Braidwood Station, Units 1 and 2
Facility Operating License Nos. NPF-72 and NPF-77
NRC Docket Nos. STN 50-456 and STN 50-457

Byron Station, Units 1 and 2
Facility Operating License Nos. NPF-37 and NPF-66
NRC Docket Nos. STN 50-454 and STN 50-455

Subject: Response to NRC Request for Additional Information With Respect to Request for License Amendment Related to Application of Alternative Radiological Source Term

Response to NRC Request for Additional Information

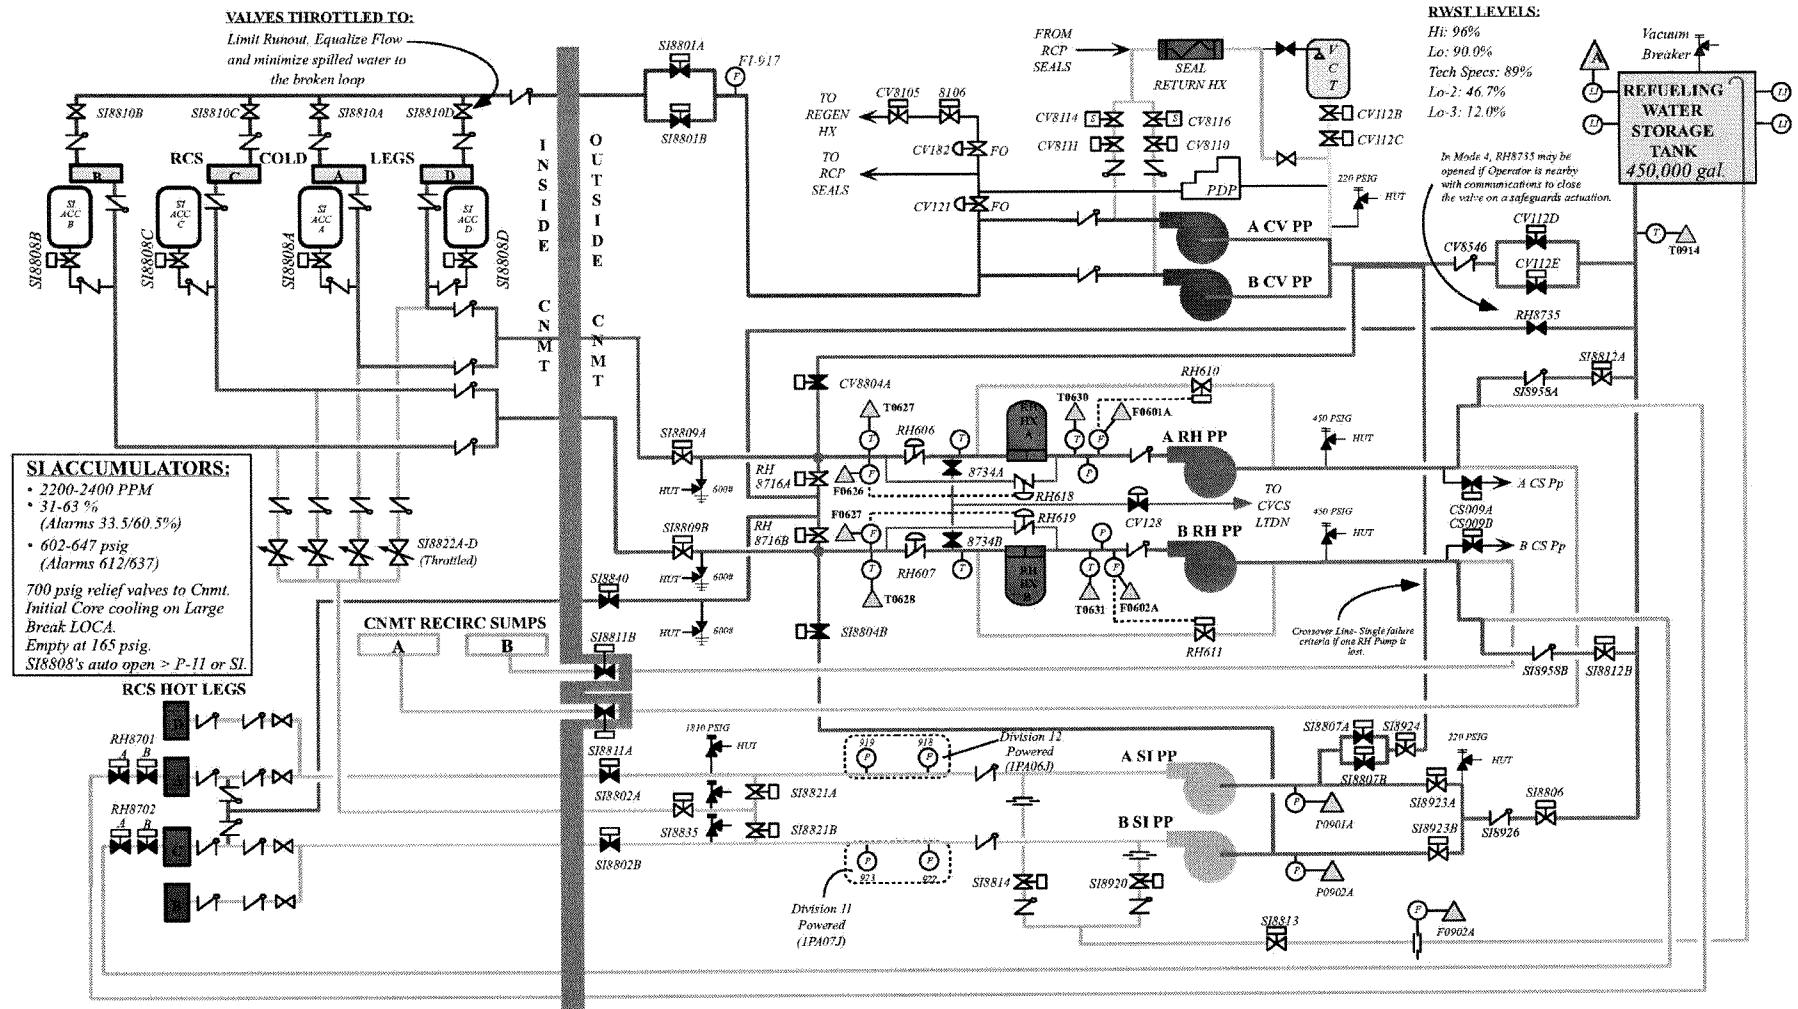
- (3) In the ECCS leakage path leading to the Borated Water Storage Tank (BWST), the sump water will mix with the remaining borated water in the tank. Since the BWST water contains between 2300 and 2500 ppm of boron in the form of boric acid, the pH of the mixture of sump and BWST water will have lower pH (most probably well below 7). Lowering the pH of the sump water will cause the conversion of ionic iodine into the elemental form and its corresponding release to the reactor water storage tank (RWST) air space. This effect will increase the total release of radioactive iodine from engineering safety features and cause correspondingly higher radiation doses.

Was this effect included in the licensee's analysis? If it was included, provide its description and the analyses for determining its significance to the overall release of radioactivity in the ECCS recirculation leakage path.

For the purposes of this response, the BWST is referred to as the RWST at Byron and Braidwood Stations. Sump leakage back to the RWST was not considered based on the design and operation of the ECCS. The ECCS is depicted in simplified diagrams ECCS-1, "ECCS System," and ECCS-2, "ECCS Ring," provided as Attachment 3 to this submittal. During the injection phase of the LOCA, water is injected from the RWST into the RCS cold legs. When the RWST Lo-2 level is reached, Emergency Operating Procedure 1/2B(w)EP ES-1.3 is entered to align the ECCS for the recirculation mode of operation, i.e., suction is switched to the containment sump. The steps for aligning the ECCS for the recirculation mode are summarized below (refer to simplified Diagram ECCS-1):

1. The containment sump isolation valves, 1/2SI8811A/B, automatically open on the RWST Lo-2 level signal.
2. Adequate containment sump water level to support ECCS pump operation is verified.

3. The containment sump isolation valves, 1/2SI8811A/B, are verified open.
4. The residual heat removal (RHR) pump suction isolation valves from the RWST (1/2SI8812A/B) are manually closed.

5. The centrifugal charging (CV) pump recirculation valves, 1/2CV8111/8114 and 1/2CV8110/8116, are isolated. It should be noted that the CV pump recirculation valves return to the pump suction and not the RWST.

6. The recirculation flow path to the RWST for the safety injection (SI) pumps is then isolated by closing 1/2SI8814, 1/2SI8920, and 1/2SI8813. At this time, the SI pumps suction is still aligned to the RWST. If RCS pressure is above the shutoff head of the SI pumps, the SI pumps will be shut down.

7. The discharge of the RHR trains is then split by closing 1/2RH8716A/B
8. The suction header for the CV and SI pumps is then cross-tied by opening 1/2SI8807A/B, and 1/2SI8924. The RWST is still the suction source to the CV and SI pumps.

9. The CV and SI pump suction is then aligned to the discharge of the RHR pumps by opening 1/2CV8804A and 1/2SI8804B. At this time, back flow into the RWST is prevented by check valve 1/2SI8926 (on SI pump suction side of 1/2SI8806) and check valve 1/2CV8546 (on CV pump suction side of 1/2CV112D and 1/2CV112E). The check valves are held closed by RHR pump discharge pressure.

10. The RWST is then isolated from the CV and SI pump suctions by closing 1/2CV112D, 1/2CV112E, and 1/2SI8806.

When the above steps are completed, the ECCS system is isolated from the RWST on both the suction side and the SI pump recirculation. The CS pumps are still running with suction aligned to the RWST. The realignment of the CS pumps to the containment sump is performed when the RWST reaches the Lo-3 level setpoint by performing the following steps (refer to simplified Diagram ECCS-2):

1. The CS pump suction from the containment sump isolation valves, 1/2CS009A/B are opened.
2. The CS pump isolation valves from the RWST, 1/2CS001A/B, are closed.

Note that in this lineup the CS pumps do not have a recirculation flow path back to the RWST. A portion of the CS pump discharge flow is directed through the CS pump eductor back to the pump suction in order to inject NaOH.

As described above, once the ECCS has been realigned for the recirculation mode of operation, potential leakage paths back to the RWST are isolated utilizing at least two valves in series, typically a check valve in combination with a motor operated valve (MOV). For a short period of time during realignment of the RHR pump suctions from the RWST to the containment sump, leakage back to the RWST is prevented by a single check valve (i.e., 1/2SI8958A/B) until the RHR pump suction isolation valves from the RWST (i.e., 1/2SI8812A/B) are closed. The ECCS valves are tested in accordance with the Inservice Testing (IST) Program required by Technical Specification 5.5.8, "Inservice Testing Program," to ensure meeting their specified engineered safety position. During testing, check valves 1/2SI8926 and 1/2CV8546, preventing back flow to the RWST, are verified closed utilizing one of the following methods: 1) ultrasonic testing, 2) acoustic testing, or 3) pressure testing. The IST of check valve 1/2SI8958A/B requires a pressure test be performed. The MOVs used to isolate flow paths back to the RWST are also stroke tested to the closed position in accordance with the IST Program. Additionally, MOVs are tested in accordance with the MOV Program used to satisfy the recommendations in Generic Letter (GL) 89-10, "Safety-Related Motor-Operated Valve Testing and Surveillance," dated June 28, 1989, and GL 96-05, "Periodic Verification of Design Basis Capability of Safety-Related Power-Operated Valves," dated September 18, 1996.

Based on the discussion above, back leakage to the RWST is not considered in the analysis, consistent with the current analysis of record.
